# intel® Technical Advisory

TA-0791-1

## Some EMI shields are difficult to remove from the floppy/HDD tray included with the Intel® Server Chassis SC5300

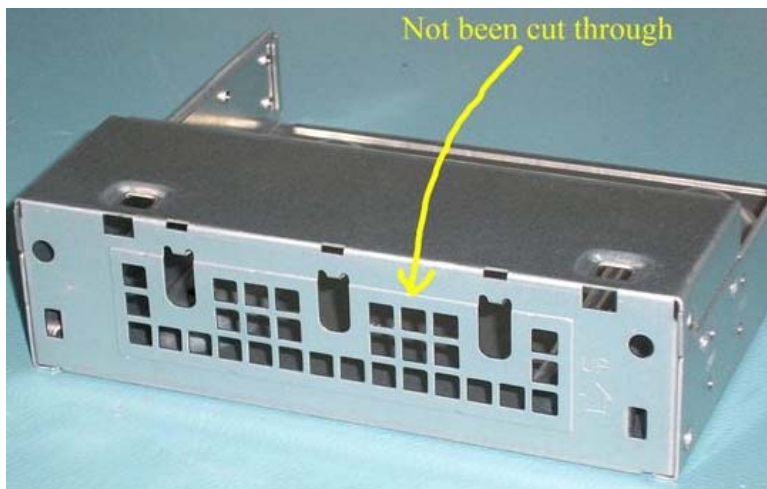
In some systems, the EMI shield in the floppy/HDD tray may not have been completely cut through making removal of the shield for floppy drives very difficult to do. Normal removal of the EMI shield should only require light to moderate force pushing from inside of the tray and possibly light manipulation with a screw driver to break the tabs.

The alignment of the tooling used to manufacture this part went outside of the part specification.

The tool has been realigned at the factory, and it has been confirmed to correctly punch the EMI shield in the tray. If you have a tray with this issue, you may return it to Intel for a corrected replacement tray. To get parts, contact Intel using your normal warranty process. Please indicate that you are calling regarding TA# 0791-1, and have the following information when you call; the part number requested (p/n for this issue is **52131581**), and the serial number(s) for the system(s) needing the replacement part.
